Access Compliance Report

Public Rights-of-Way

(Curb Ramps)

Intersection ID: 19433	Main Street: SHARON_RD	Cross Street: MORROCROFT_LN	Location: SW
ADA ID: 19DFC04549CE	Ramp Type: PerpDiag	Initial Pass/Fail: Fail	Overall Compliance: No
		Severity Score: 21.25

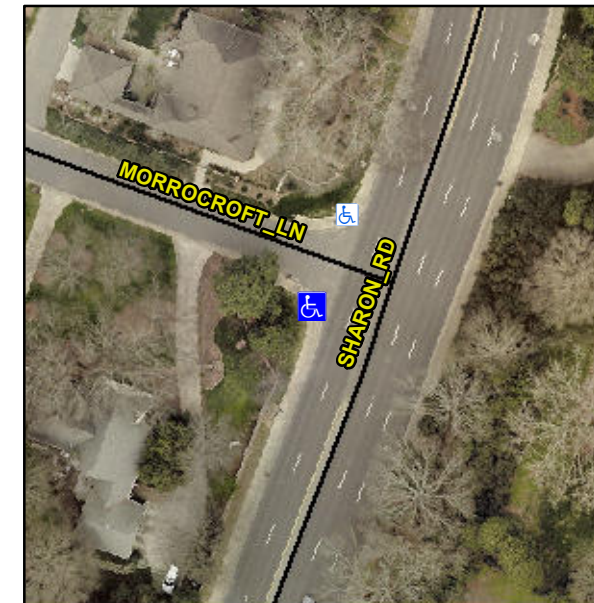
Not Found, R304.5.1, R304.2.2

Compliance	Description	Data	Compliance	Description	Data
N/A	Ramp Length (in)	60.0	No	Ramp Slope (%)	11.9
No	Ramp Width (in)	39.0	Yes	Ramp XSlope (%)	0.1
N/A	Flare Type LT	N/A	N/A	Flare Type RT	N/A
N/A	Flare Slope LT (%)	N/A	N/A	Flare Slope RT (%)	N/A
N/A	Flare Traversable LT?	N/A	N/A	Flare Traversable RT?	N/A
N/A	Landing Length (in)	N/A	N/A	DWS Provided?	N/A
N/A	Landing Width (in)	N/A	N/A	DWS Contrast?	N/A
N/A	Landing Slope (%)	N/A	N/A	DWS Length (in)	N/A
N/A	Landing X Slope (%)	N/A	N/A	DWS Full Width?	N/A
N/A	Landing Curb? (Y/N)	N/A	N/A	DWS Offset (in)	N/A
N/A	Shared Landing?	N/A			
N/A	Gutter Ponding?	N/A	N/A	Gutter Slope (%)	N/A
N/A	Gutter Lip Ht (in)	N/A	N/A	Gutter X Slope (%)	N/A
N/A	Painted X Walk1?	No	N/A	Painted X Walk2?	No
	X Walk 1 Direction	To SE		X Walk 2 Direction	To NE
N/A	X Walk 1 Width (in)	N/A	N/A	X Walk 2 Width (in)	N/A
	X Walk 1 Slope (%)	0.7		X Walk 2 Slope (%)	0.9
	X Walk 1 X Slope (%)	0.2		X Walk 2 X Slope (%)	1.8

Remove & Replace Curb Ramp With Two New Directional Ramps or Equivalent.
